To: T10 Technical Committee
 From: Rob Elliott, HP (elliott@hp.com)
 Date: 12 April 2007
 Subject: 07-178r0 SAS-2 Connection request livelock avoidance

Figure 1 — SSP-only connection livelock example

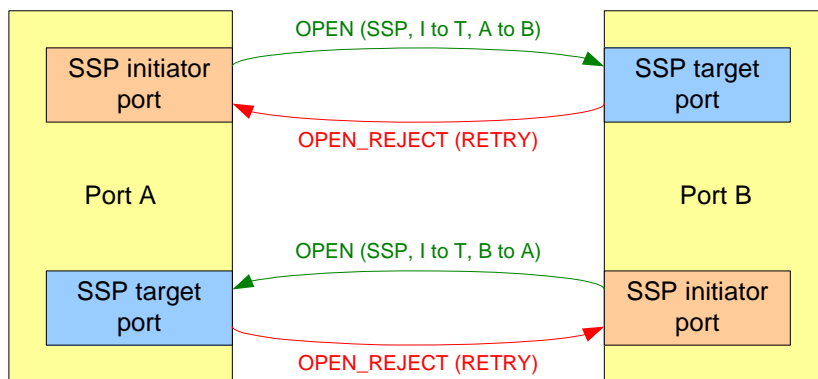
2. Phys supporting both initiator and target roles must take care not to create livelocks.

Figure 1 shows an example of SSP ports supporting both target and initiator roles.

- a) a SAS phy shall not reject an incoming connection request to an SSP initiator port with OPEN_REJECT (RETRY) because the SAS port containing that SAS phy needs an outgoing connection request to be accepted (e.g., if the SAS phy is used by an SSP initiator port and an SSP target port, they share a buffer, that buffer is being used by the SSP target port, and the SSP target port needs to transmit a frame to another SSP initiator port before it is able to free that buffer);

Figure 2 — SSP/STP connection livelock example

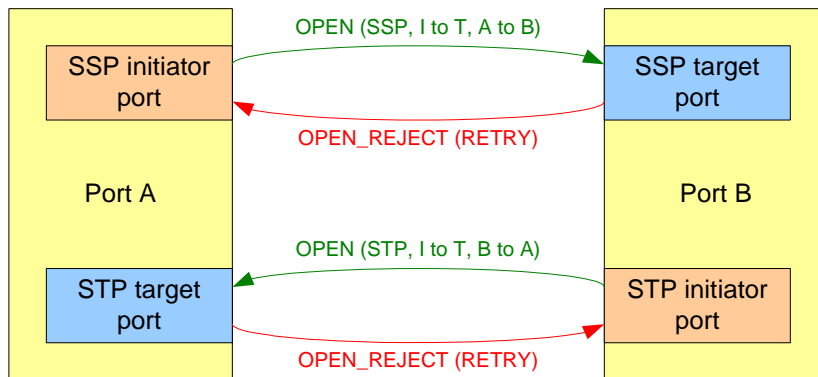
Figure 2 shows an example of ports with initiators and targets of different protocols.

Assume phy A's STP target port is sharing a buffer with phy A's SSP initiator port, and the STP target port is using that buffer and needs to send a frame to phy B's STP initiator port to free the buffer. Section 7.15.8 (Opening STP connections) allows STP target ports to reject incoming connection requests while trying to establish their own outgoing connections.

Assume phy B's SSP target port is sharing a buffer with phy B's STP initiator port, and the SSP target port is using that buffer and needs to send a frame to phy A's SSP initiator port to free the buffer. Section 7.16.1 (per issue #1) allows SSP target ports allows to reject incoming connection requests while trying to establish their own outgoing connections.

These combine into a livelock, where neither phy A nor phy B is able to free its buffer as they continually reject each others' connection requests.

To avoid this, the target allowance for sending OPEN_REJECT (RETRY) because it needs to win an outgoing connection needs to be further constrained. If an initiator and target are sharing a phy (regardless of protocol), the phy must accept an incoming connection request destined to its initiator role without waiting for any of its outgoing connection requests to win.
